UNITED STATES PATENT AND TRADEMARK OFFICE

Office Action Summary	Application No. 10/719,352	Applicant(s) WALL, JOHN R.	
	Examiner Daniel J. Mills	Art Unit 3679

DETAILED ACTION

Claims 1, 3-12 are rejected under 35 U.S.C. 103(a) as being unpatentable over Safe-Fence as shown on the April 8, 2001 archive of www.safefence.com accessible using the internet archive website "wayback machine" at:

Figure 1

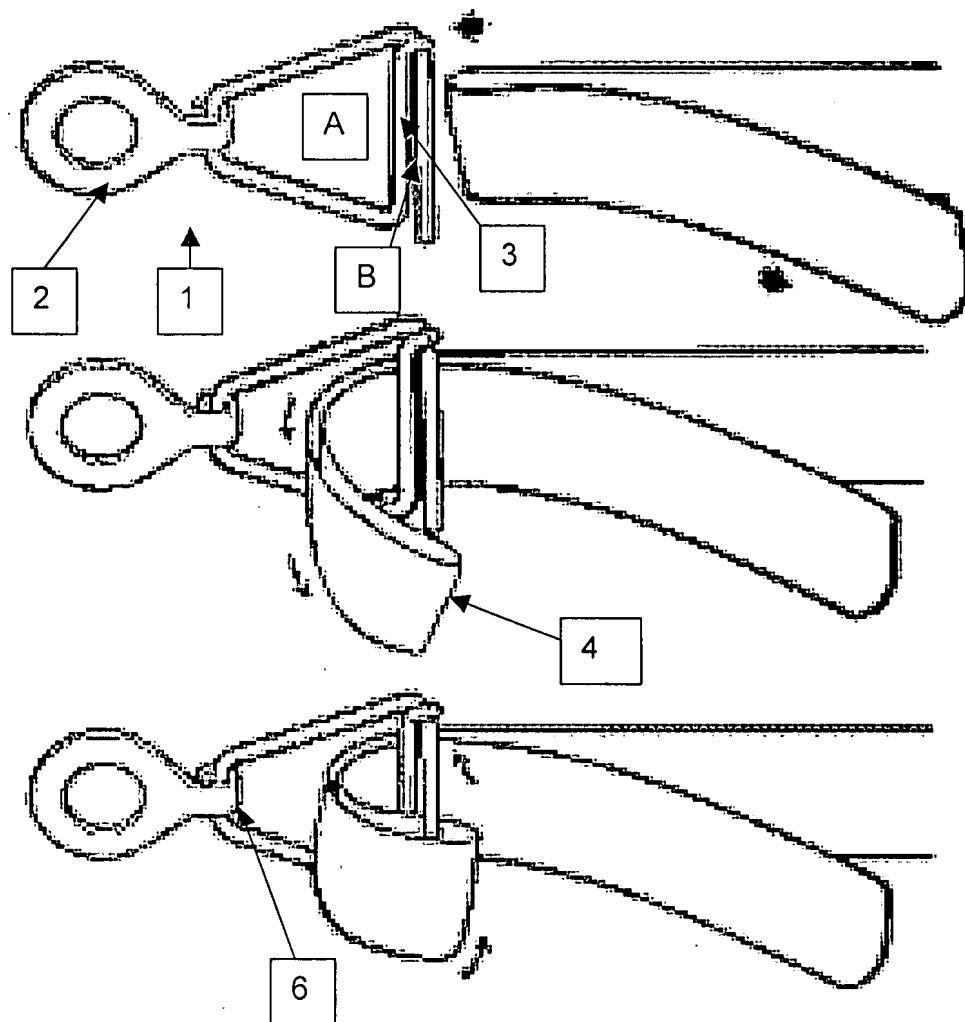
disclosed as having stainless steel wires interwoven), a slotted connector (1) having a face plate (encompasses the entirety of 1) with two slots (A and B) and a middle portion (3) separating the two slots, the connector having a front side (facing away from reader) and a rear side (facing toward reader) and also having a post attachment end (2), a free end of the rail (4) being disposed in the slotted connector so that the rail runs from the front side of the connector through a first slot (A) nearest the post attachment end, round the middle portion (3), and then back through the second slot (B), and a post (5) to which the slotted connector is attached using a fastener (5).

Regarding claim 3, Safe-Fence in view of Johnson and Robbins Jr. results in a fence wherein the end connector is attached to the post using a fastener (see figure 1) which permits the connector to pivot about the fastener.

Regarding claim 4, Safe-Fence in view of Johnson and Robbins Jr. results in a fence wherein the faceplate further comprises a through hole (see 2) adapted to receive the fastener.

Regarding claim 6, Safe-Fence in view of Johnson and Robbins Jr. results in a fence wherein the faceplate (encompasses the entirety of 1 includes a bend between the first slot and the post attachment end (2) (this is shown in figure 1 in the photo of the R-50 corner tensioner).

Regarding claim 2, Safe-Fence in view of Brattstrom and Robbins Jr. results in a fence wherein the end connector comprises return edges extending along opposing sides of the rigid member, the return edges extending perpendicularly from the faceplate (the hooks 6 shown on either side of component 2 on the R-50 corner tensioner, curve perpendicularly away from the plane of the faceplate).

Regarding claim 6, Safe-Fence in view of Brattstrom and Robbins Jr. results in a fence wherein the faceplate (encompasses the entirety of 1 includes a bend between the first slot and the post attachment end (2) (this is shown in figure 1 in the photo of the R-50 corner tensioner).
